Access Compliance Report

Public Rights-of-Way

(Curb Ramps)

Intersection ID: N/A	Main Street: BEREWICK COMMONS PKY	Cross Street: GLENBURN LN	Location: SW
ADA ID: DA74940FE322	Ramp Type: PerpDiag	Initial Pass/Fail: Fail	Overall Compliance: No
Severity Score: 21.25			
Codes/Mitigation Info/Possible Solution		Field Measurements/Component Compliance

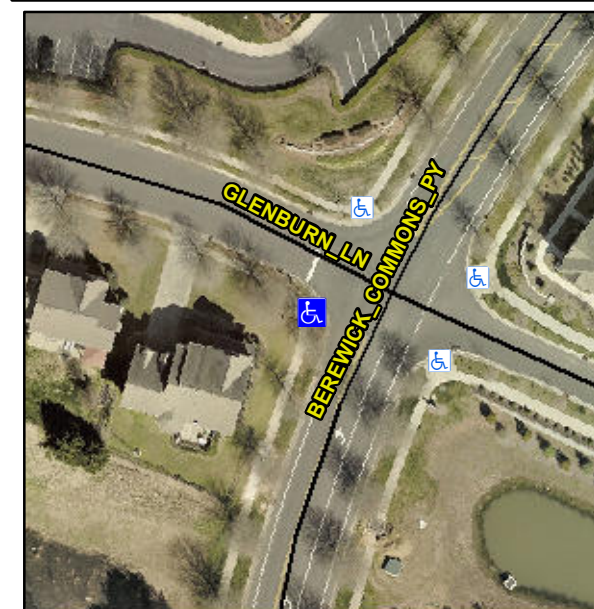
Not Found, R304.5.1, R304.5.3

Compliance	Description	Data	Compliance	Description	Data
N/A	Ramp Length (in)	90.0	Yes	Ramp Slope (%)	6.5
No	Ramp Width (in)	45.0	No	Ramp XSlope (%)	6.8
N/A	Flare Type LT	N/A	N/A	Flare Type RT	N/A
N/A	Flare Slope LT (%)	N/A	N/A	Flare Slope RT (%)	N/A
N/A	Flare Traversable LT?	N/A	N/A	Flare Traversable RT?	N/A
N/A	Landing Length (in)	N/A	N/A	DWS Provided?	N/A
N/A	Landing Width (in)	N/A	N/A	DWS Contrast?	N/A
N/A	Landing Slope (%)	N/A	N/A	DWS Length (in)	N/A
N/A	Landing X Slope (%)	N/A	N/A	DWS Full Width?	N/A
N/A	Landing Curb? (Y/N)	N/A	N/A	DWS Offset (in)	N/A
N/A	Shared Landing?	N/A			
N/A	Gutter Ponding?	N/A	N/A	Gutter Slope (%)	N/A
N/A	Gutter Lip Ht (in)	N/A	N/A	Gutter X Slope (%)	N/A
N/A	Painted X Walk1?	No	N/A	Painted X Walk2?	No
	X Walk 1 Direction	To SE		X Walk 2 Direction	To NE
N/A	X Walk 1 Width (in)	N/A	N/A	X Walk 2 Width (in)	N/A
	X Walk 1 Slope (%)	0.5		X Walk 2 Slope (%)	4.7
	X Walk 1 X Slope (%)	6.7		X Walk 2 X Slope (%)	3.3

N/A	Ramp inside XWalk1?	N/A	N/A	Ramp inside XWalk2?	N/A
	Road Slope (%)	5.6	N/A	Clear Space?	N/A
	Road X Slope (%)	4.2	N/A	Clear Space to XWalk (in)	N/A
N/A	Any Obstructions?	N/A	N/A	Storm Grate/Utility Hazard?	N/A
	Obstruction Type			Storm Grate/Utility Type	
		N/A			N/A
			Yes	Surface Condition? (G/P)	Good

Remove & Replace Curb Ramp With Two New Directional Ramps or Equivalent.
